Mekong River Commission
For Sustainable Development

TECHNICAL REVIEW REPORT

Prior Consultation for the Proposed Pak Lay Hydropower Project

Prepared by Mekong River Commission Secretariat
15 March 2019

Figure 3.2 The proposed operating rule for the PLHPP during normal and flood operations.

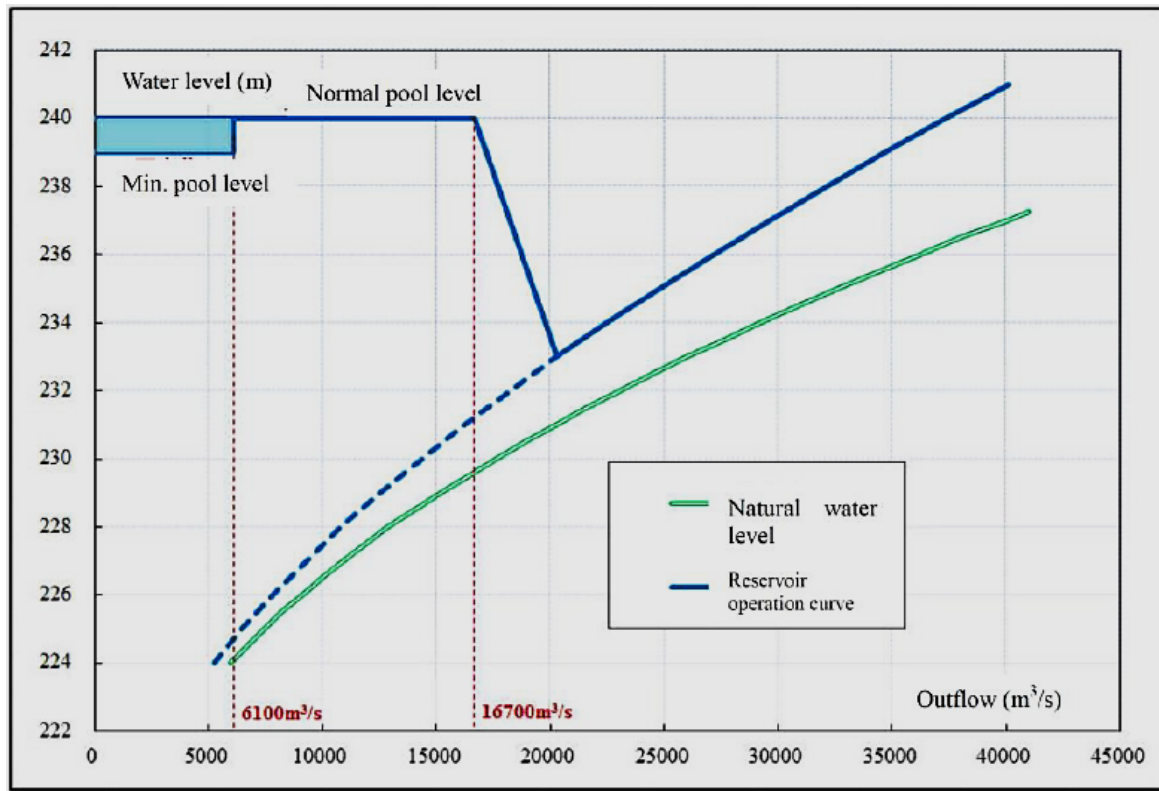
It is assumed that downstream water levels will vary by less than 2.2 m/day, but there is no evidence provided for this determination. (This may be derived from a computational model used to estimate these water levels and discharges). The developer suggests that because the Mekong is still in flood at these times these downstream level fluctuations are acceptable.

Figure 4.1 Monthly average discharge for a year with an annual average flow frequency of 2% (data from the developer). The maximum operating flow for the Xayaburi fishpass and Pak Lay fishpass (proposed). The upstream and downstream migration season is shown with the

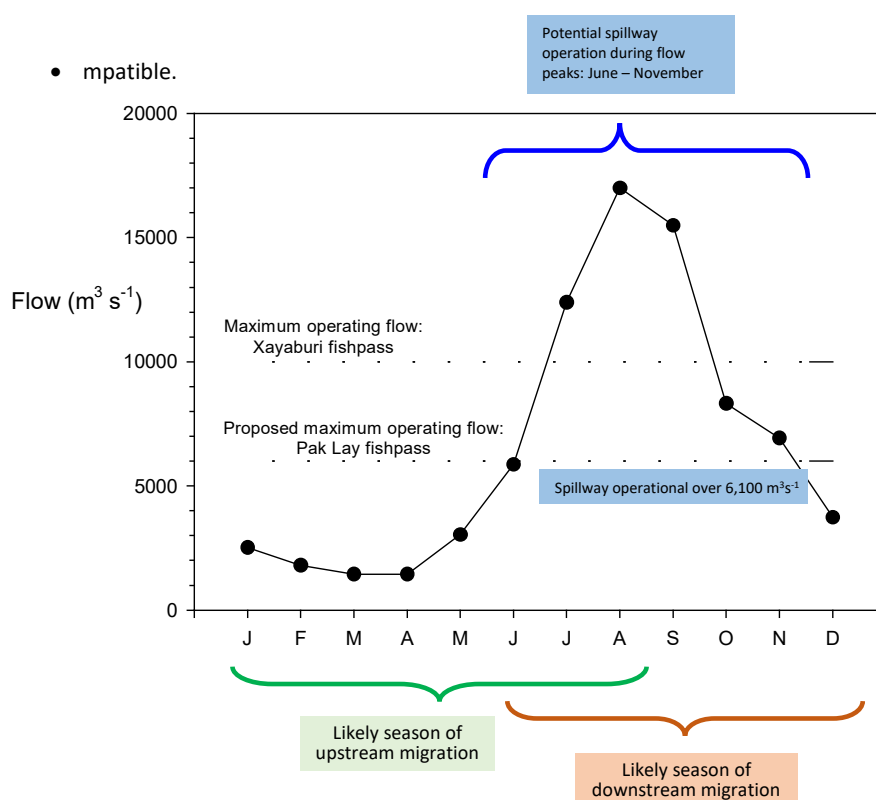
fishway to operate for 90% of the entire year, including the peak rainy season months of September and October, as well as the dry season (December to May). It is recommended that the PLHPP should aim to allow fish migration for 90% of the time to align better with the operational periods at Xayaburi (see figure 4.1)²⁷.

A critical cue for migration for Mekong fish is flow. Figure 4.1 shows the average monthly discharge for a wet year (2% annual average flow frequency), showing the likely months of upstream and downstream migration; the likely months of spillway operation; and the fishpass operating flows for both Xayaburi and Pak Lay fishpasses.

Figure 4.2. Layout of PLHPP showing key recommendations.

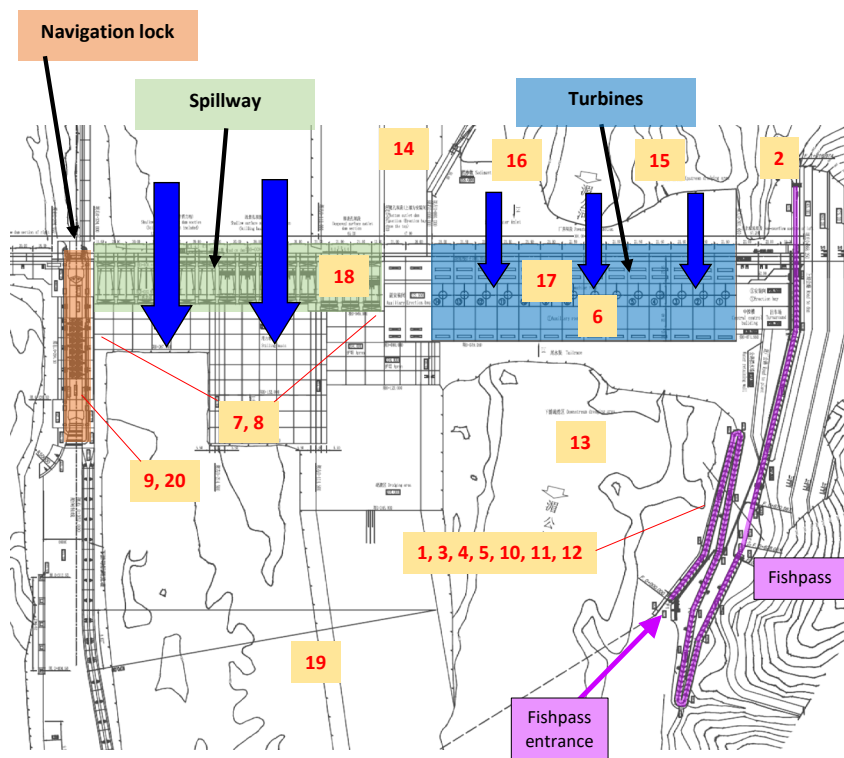
The key recommendations for the fish passage are summarised below and aligned with the numbers in Figure 4.2. An overarching theme is that fish passage at the PLHPP needs to meet the PDG requirements, or at least have compatible function with the Xayaburi HPP, which is immediately upstream.

Key Recommendations for Fish Passage (numbers refer to Figure 4.2).
